**PUBLIC COMMENTS REPORT  
ON  
ICC A117.1 STANDARD  
SECOND PUBLIC REVIEW DRAFT**

**JANUARY 2, 2015**

**ICC/ANSI A117.1 STANDARD  
DEVELOPMENT - 2015 EDITION**

## **ICC A117.1 Standard – Accessible and Usable Buildings and Facilities Second Public Review Draft Public Comment Report – January 2, 2015**

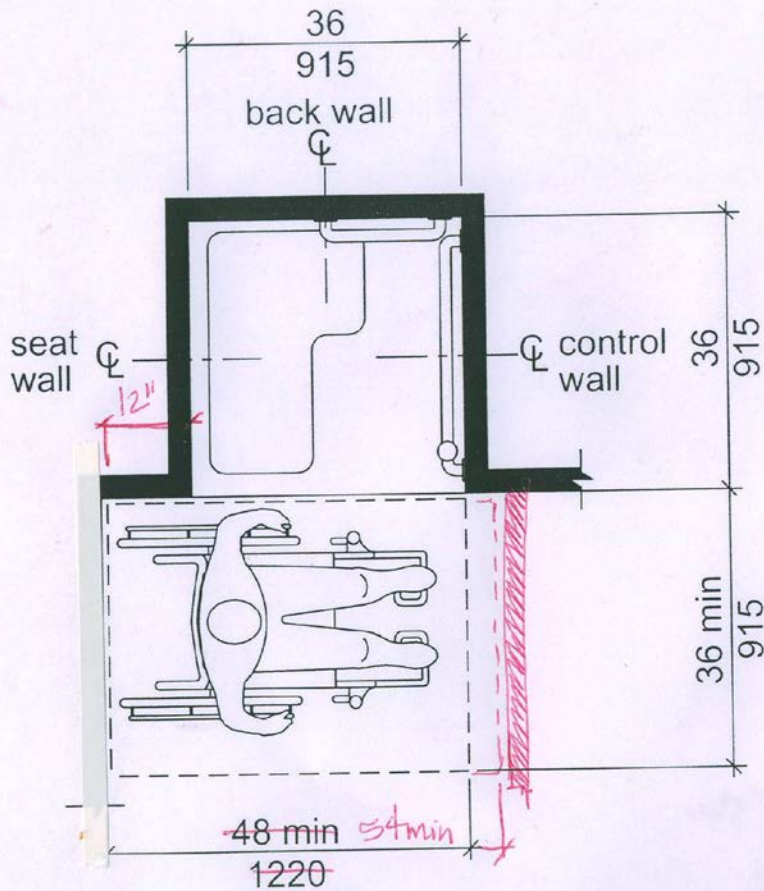
<b>6-37-12 PC1</b>	
<b>Agenda Item #24</b>	
<b>Comment No:</b> 6-37-12 PC1.1	<b>Submitted by:</b> Matt Sigler - PMI
	<p><b>Further revise as follows:</b></p> <p><b>606.5 Basin Location.</b> The interior edge of the rim of the lavatory basin shall be located <math>3\frac{1}{2}</math> inches (<del>90</del> <u>150</u> mm) maximum from the front edge of the fixture or countertop.</p>
<p><b>Reason:</b> PMI is very much against the original proposal of 3 inches, and this public comment that revises the dimension to 3-1/2 inches for the following reasons:</p> <ol style="list-style-type: none"> <li>1. There are many lavatories in the market that have been acceptable for years with setbacks of up to 5 or more inches to gain the required knee clearance as stated in Section 306.3.</li> <li>2. According to studies conducted by Kohler, lavatories can be very uncomfortable even painful to use when the rims are moved so far forward on the counter as would be the case with the proposed language. People would be resting their forearms or wrists on the rims of the lavatories that can cause a pinching sensation of the wrists and soreness of the underside of the forearms.</li> <li>3. The further forward a lavatory is set there is greater propensity for splashing because of the angle of discharge from the faucet.</li> <li>4. There is no known study that supports the proposed setbacks. Therefore, a task group should be formed to review this proposal before being considered by the committee for inclusion into the standard.</li> </ol> <p>As it is too late in the process to eliminate this new requirement, we are offering a dimension that should be appropriate for the fixtures that are available on the market and provides that the original issue is still addressed. We are still researching with our member manufacturers as to what would be the best distance. We will bring out findings to the February 2015 meeting and may suggest a distance different than 6 inches.</p>

<b>6-37-12 PC1 - AS PUBLISHED 2<sup>ND</sup> PUBLIC REVIEW DRAFT</b>	
<p><b>Revise as follows:</b></p> <p><b>606.5 Basin Location.</b> The interior edge of the rim of the lavatory basin shall be located <math>3\frac{1}{2}</math> inches (<del>75</del> <u>90</u> mm) maximum from the front edge of the fixture or countertop.</p>

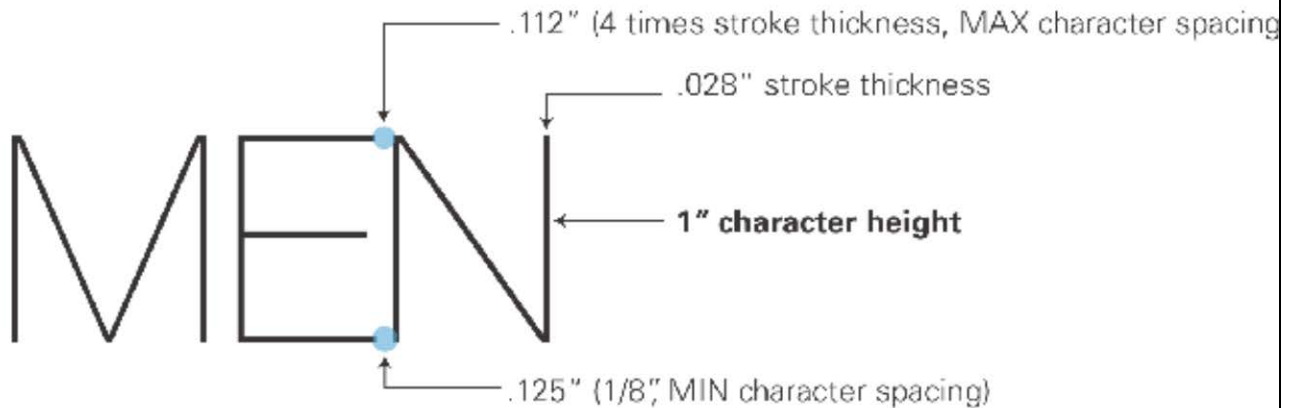
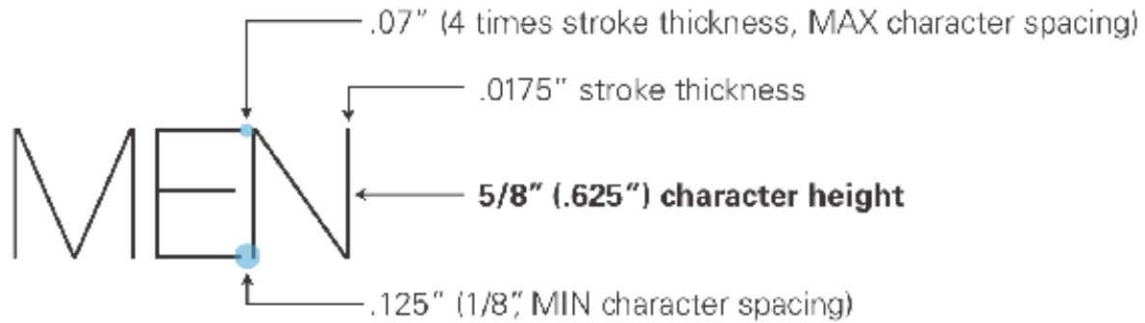
<b>7-1-12 PC3</b>	
<b>Agenda Item #35</b>	
<b>Comment No: 7-1-12 PC3.1</b>	<b>Submitted by: Sharon Toji – HLAA Eugene Lozano, Jr. – California Council of the Blind Billie Lousie (Beezy) Bentzen – Accessible Design for the Blind on behalf of AERBVI</b>
	<p><b>Further revise as follows:</b></p> <p><b><u>105.2.XX Light reflectance value (LRV) of a surface.</u></b> Method of Test. BS 8493:2008 + A1: 2010 (British Standards Institution, 389 Chiswick High Road, London W4 4AL, United Kingdom).</p> <p><b><u>504.5.1 Visual Contrast.</u></b> The leading 2 inches (51 mm) of the tread shall have visual contrast of dark-on-light or light-on-dark from the remainder of the tread. The Light Reflectance Value (LRV) of the 2-inch (51 mm) stripe and tread shall contrast 70 percent minimum, as determined in accordance with Equation 7-1. The lighter surface shall have a LRV of not less than 45.</p> <p><b><u>701.1.2 Light Reflectance Value.</u></b> The light reflectance value (LRV) of surfaces shall be determined in accordance with BS 8493 for the following surface types:</p> <ol style="list-style-type: none"> <li><u>1. Opaque paint coatings and paint systems, including those that cause extreme angular dependences of reflected light and those that have a surface texture of less than 2 mm;</u></li> <li><u>2. Opaque coverings including those that cause extreme angular dependences of reflected light, and those that have an unyielding texture of less than 2 mm;</u></li> <li><u>3. Opaque coverings with a yielding pile, e.g. carpet;</u></li> <li><u>4. Opaque materials, including those that cause extreme angular dependences of reflected light, and those that have a texture of less than 2 mm, e.g. finished metals;</u></li> <li><u>5. Opaque materials coated with non-opaque coatings or coverings, e.g. timber door coated with a woodstain, including those that cause extreme angular dependences of reflected light, and those that have a texture of less than 2 mm;</u></li> <li><u>6. Multi-colored surfaces;</u></li> <li><u>7. Ordinary materials as defined in 3. Terms and Definitions, 3.3, by BS 8493:2008 + A1: 2010;</u></li> </ol> <p><b><u>701.1.2.1 Other Surfaces.</u></b> Other surfaces shall comply with Section 703.1.3.1.</p> <p><b><u>701.1.3 Contrast Value.</u></b> The contrast between the LRVs of adjacent surfaces required by Sections 703.2.1.2, 703.5.3.2, 703.6.3.2, 705.3, and 504.5.1 shall be determined by Equation 7-1,</p> $\text{Contrast} = [(B1-B2)/B1] \times 100 \text{ percent} \quad \text{Equation 7-1}$ <p>Where</p> <p><u>B1 = light reflectance value (LRV) of the lighter surface,</u>  <u>B2 = light reflectance value (LRV) of the darker surface.</u></p> <p><b><u>701.1.3.1 Other Surfaces.</u></b> Surfaces not within the scope of BS 8493 shall provide contrast between adjacent surfaces that are either light on dark or dark on light.</p>

**703.6.2 Finish and Contrast.** Symbols of accessibility and their backgrounds shall have non-glare finish. Symbols of accessibility shall contrast with their backgrounds with either a light symbol on a dark background or a dark symbol on a light background.

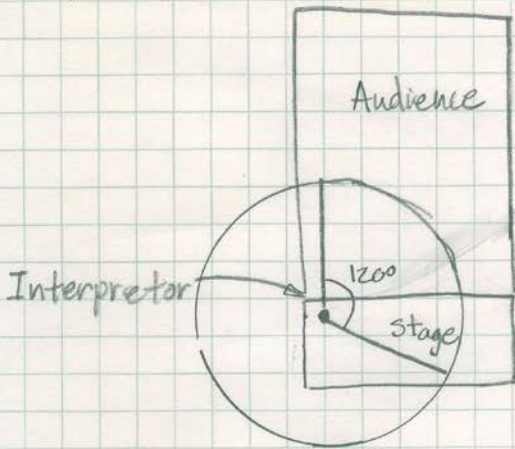
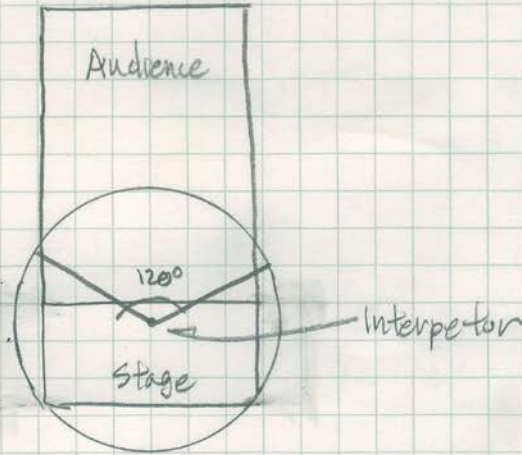
802.11.2 - The word subtend is defined in the dictionary as follows:

In geometry, an angle subtended by an arc, line, or other curve is one whose two rays pass through the endpoints of the arc. The precise meaning varies with the context. For example, one may speak of the angle subtended by an arc of a circumference when the angle's vertex is a point on the circumference. A simple theorem of plane geometry states that arcs of equal lengths subtend equal angles in such a situation.

Assuming this is the range for where the seats that have a good view of the interpreter are required, if an interpreter was standing in the middle of the stage, this might be doable. However, the most common place for an interpreter is at the side of the stage. This literally would require the viewing area to be behind them. See Figures. The maximum” could be read to indicate that the angle could be anything up to that range in width – including 0 degrees – which I don't think was the intent. ‘Unobstructed’ to 65 feet could be interpreted to not allow any columns in the room in that area. Thus the room we have our A117.1 meetings in would be in violation. Since an interpreter could be of any height, using the size of the interpreter for the viewing range is not consistent.

The intent of the revisions to the last sentence is intended to provide more precise information of measurement. However, this requirement should probably be deleted because it could prohibit seating immediately in front of the interpreter when the interpreter is on any type of raised platform or stage.
